8.1 MAREEBA 232 PTY LTD - MATERIAL CHANGE OF USE - SHOPPING CENTRE AND FOOD AND DRINK OUTLET - LOT 78 ON SP298287 AND LEASE A IN LOT 20 ON NR7137 - 232 BYRNES STREET AND CLOSE STREET, MAREEBA - MCU/22/0003

Date Prepared: 8 February 2023

SARA referral agency response—232 Byrnes Street, Mareeba and 13 Close Street, Mareeba—Shopping Centre, Food and Drink Outlet and Shop

SITE PLAN
As indicated @ A1
19/12/2022
A1.01
rev. 18A

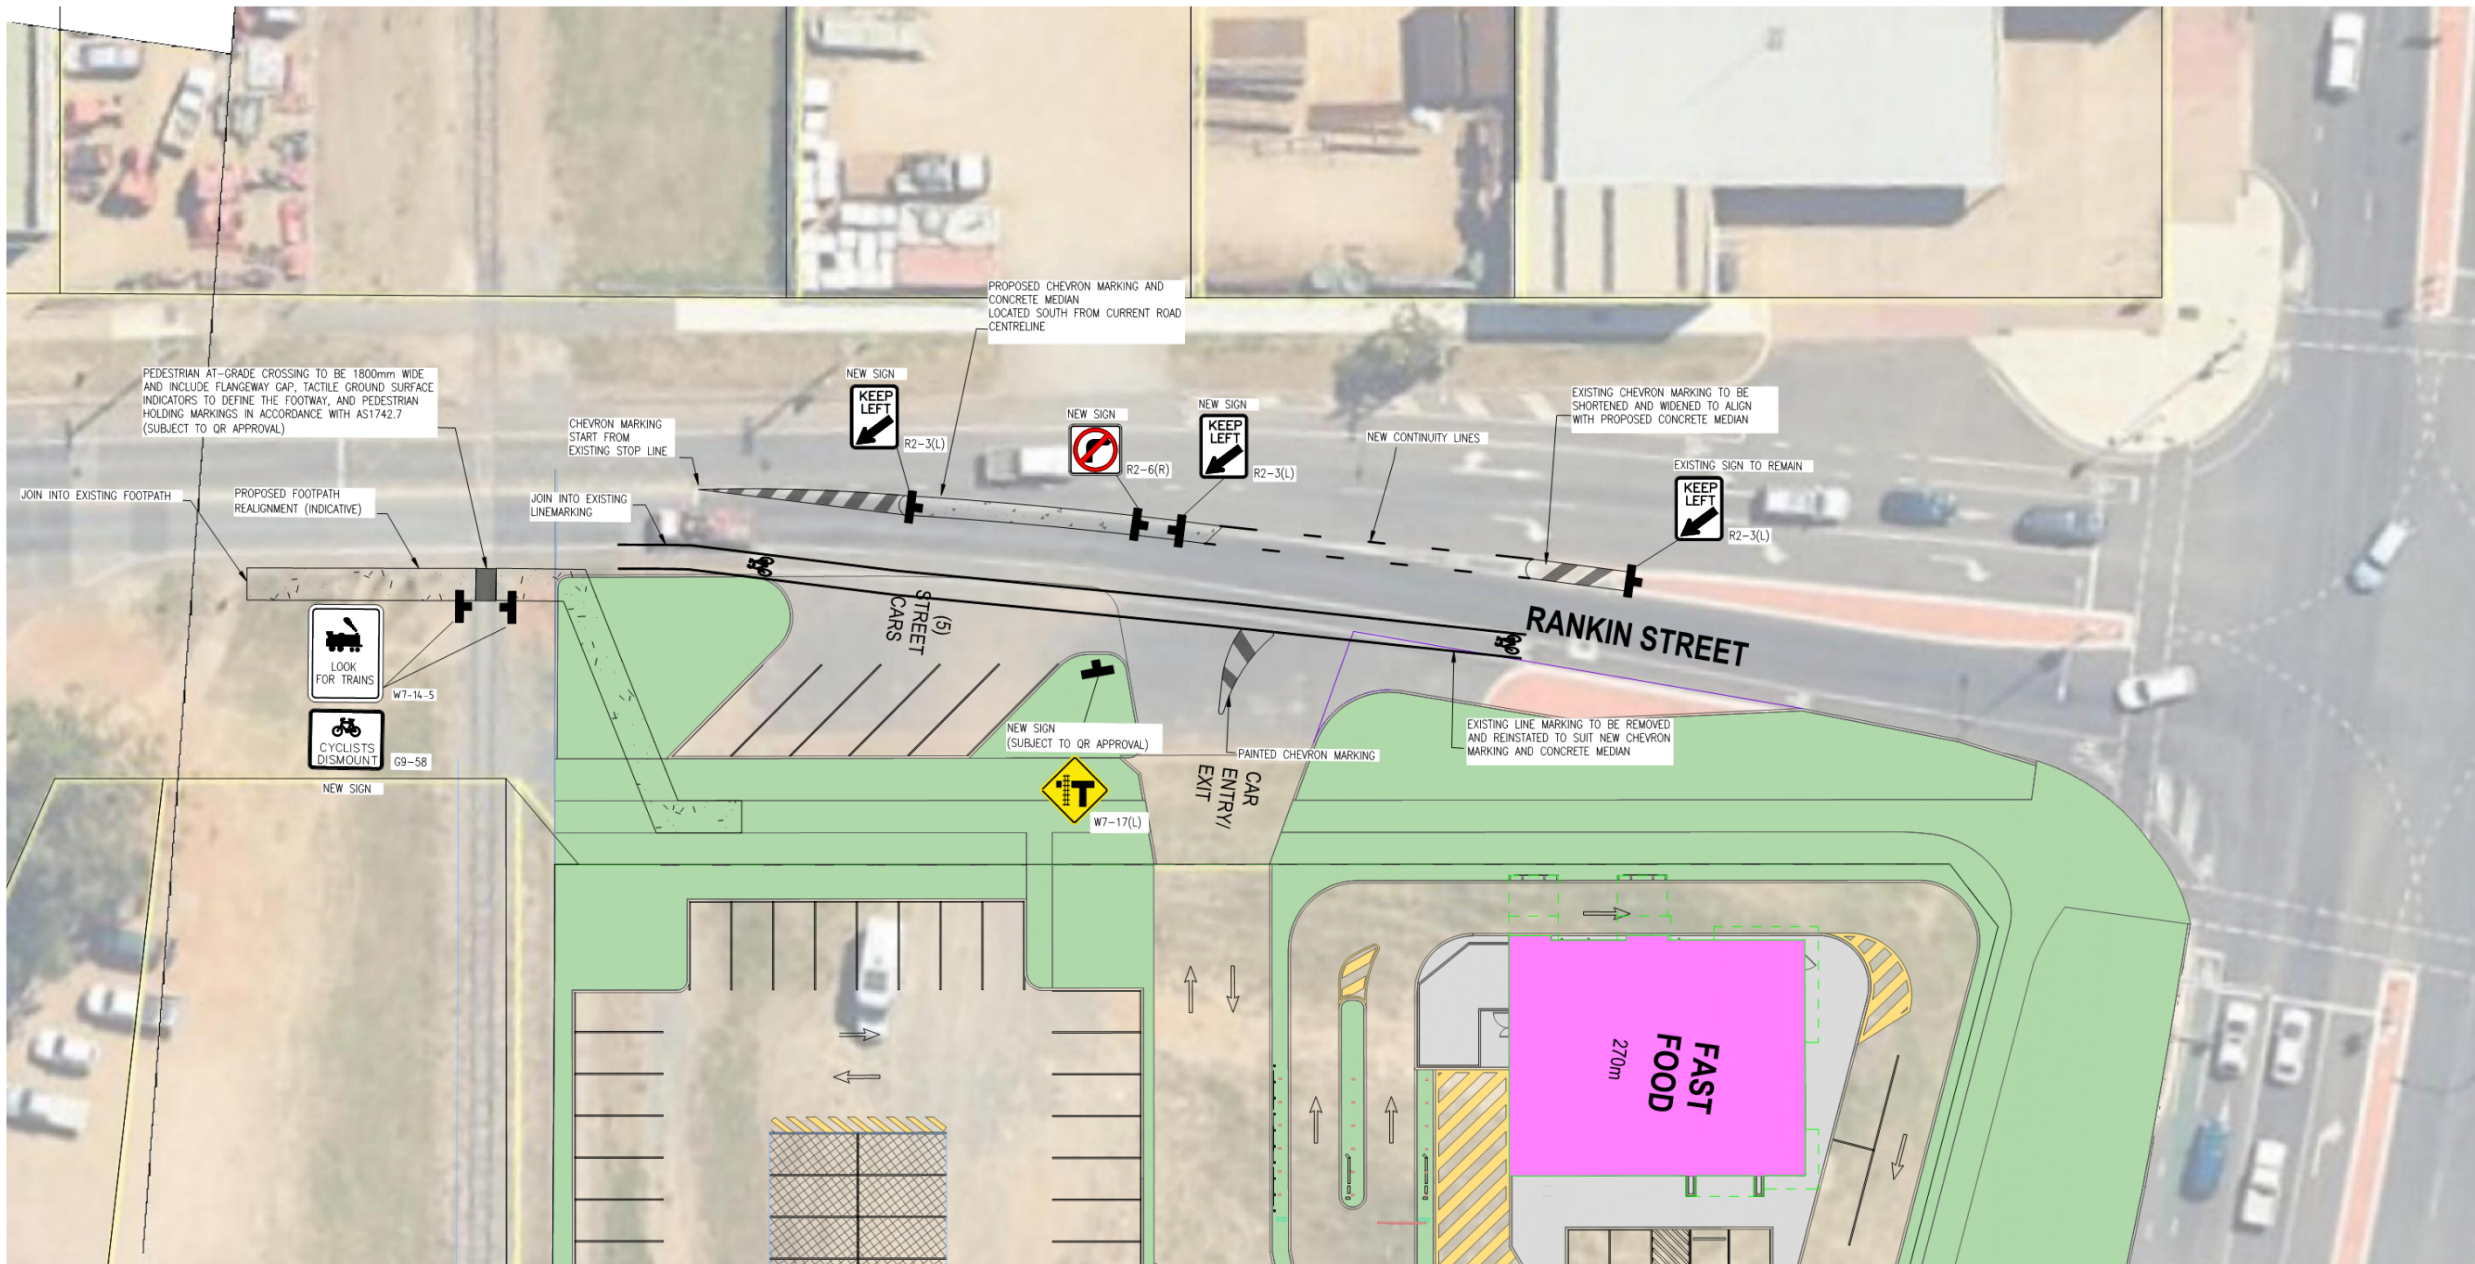
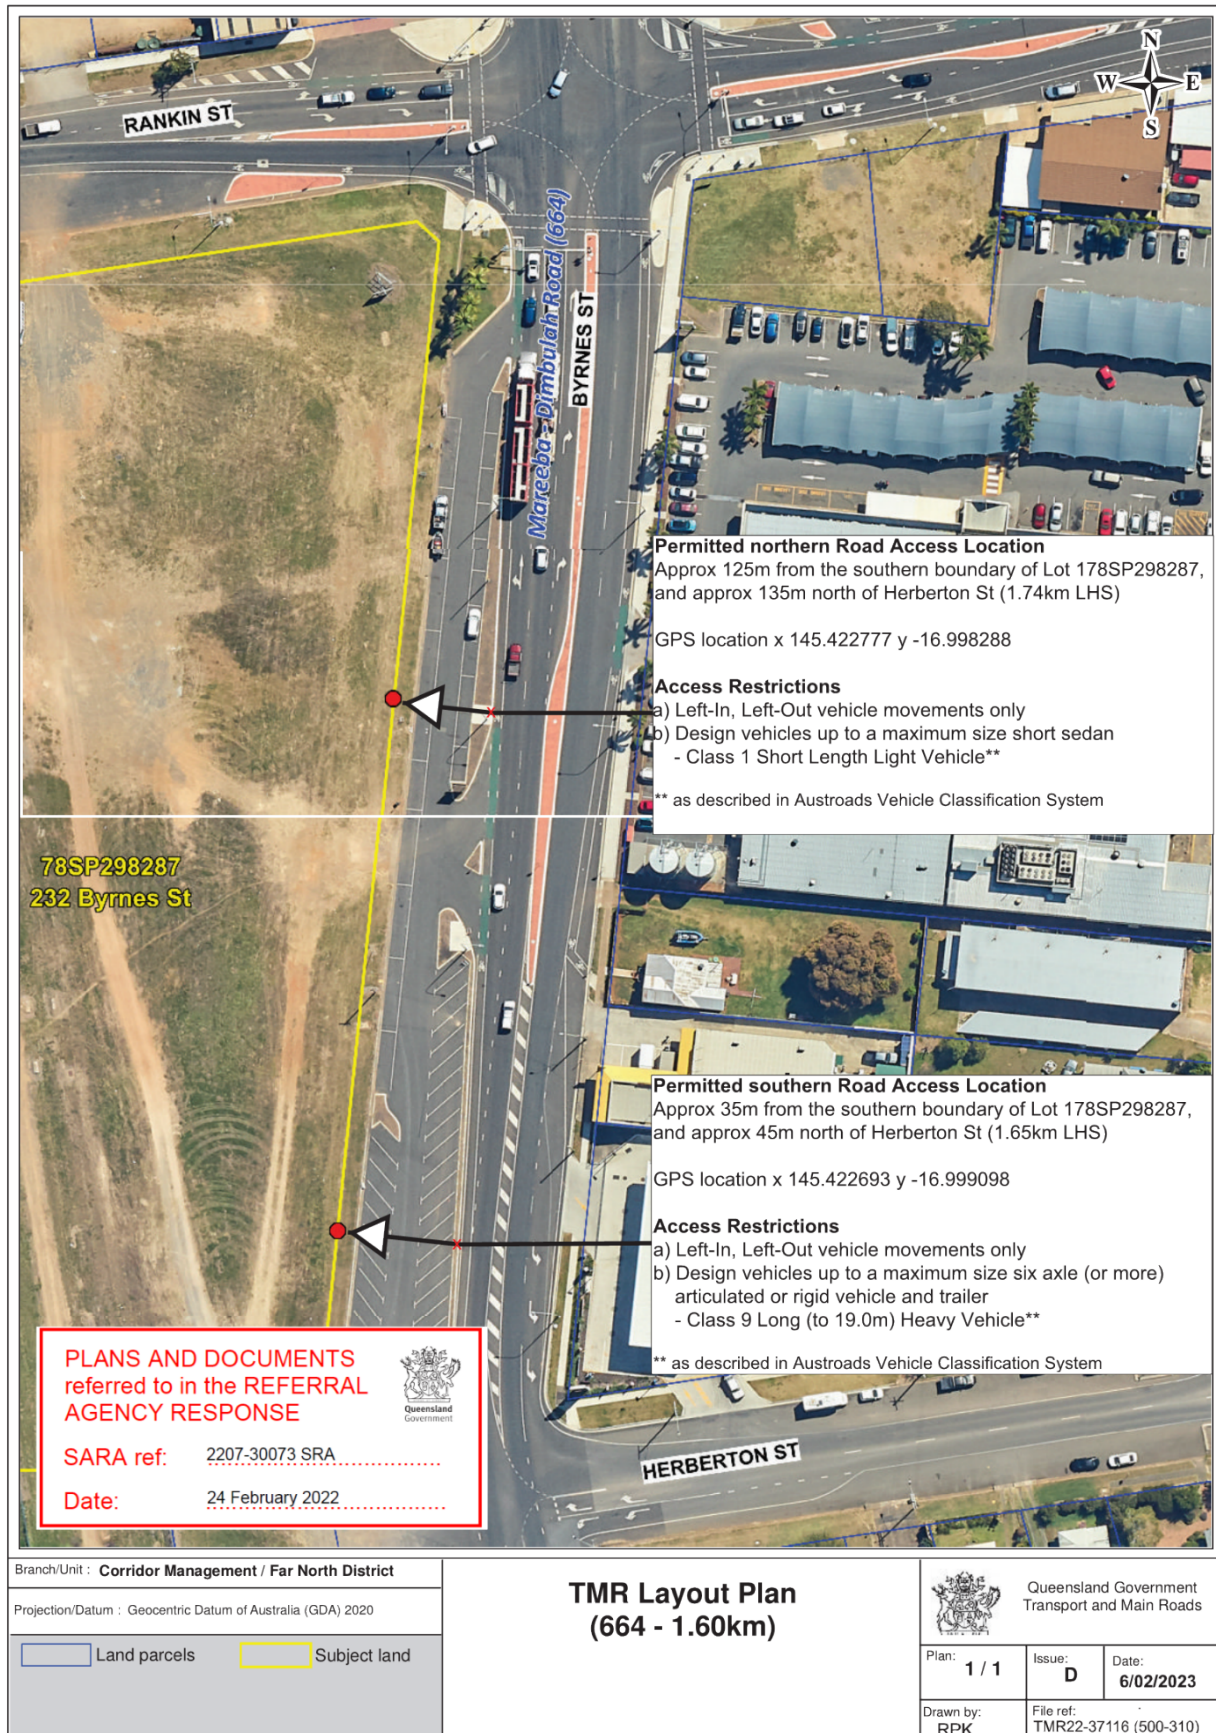
1.	Locate the shops and supermarket generally in accordance with the Site Plan, prepared by Thomson Adsett, dated 19 December 2022, drawing number A1.01, revision 18A (as amended in red) to achieve the following minimum setbacks to the railway corridor: (a) Shops – 2.4m (b) Supermarket – 1.5m	Prior to the commencement of use and to be maintained at all times.

2.	Locate the Rankin Street site access generally in accordance with the Site Plan, prepared by Thomson Adsett, dated 19 December 2022, drawing number A1.01, revision 18A (as amended in red) to achieve a minimum setback of 35m to the railway corridor.	Prior to the commencement of use and to be maintained at all times.

3.	Provide raised kerb wheel stops to all car parking spaces located perpendicular to the railway corridor as shown on the Site Plan, prepared by Thomson Adsett, dated 19 December 2022, drawing number A1.01, revision 18A (as amended in red).	Prior to the commencement of use and to be maintained at all times

9.	<p>(a) Provide a dedicated taxi rank parallel to the kerb within the location shown on the Site Plan, prepared by Thomson Adsett, dated 19 December 2022, drawing number A1.01, revision 18A (as amended in red).</p> <p>(b) The dedicated taxi rank must be designed and constructed to include the following:</p> <ul style="list-style-type: none"> (i) a minimum of two (2) taxi parking bays in total in accordance with AS2890.5 - Parking facilities, Part 5: On-street parking; (ii) of the taxi bays provided, at least one (1) is to be of a length and width suitable for use by people with disabilities in accordance AS1428.1 - Design for access and mobility and AS2890.6 – Parking Facilities, Part 6: Off-street parking for people with disabilities 	(a) & (b) Prior to the commencement of use and to be maintained at all times
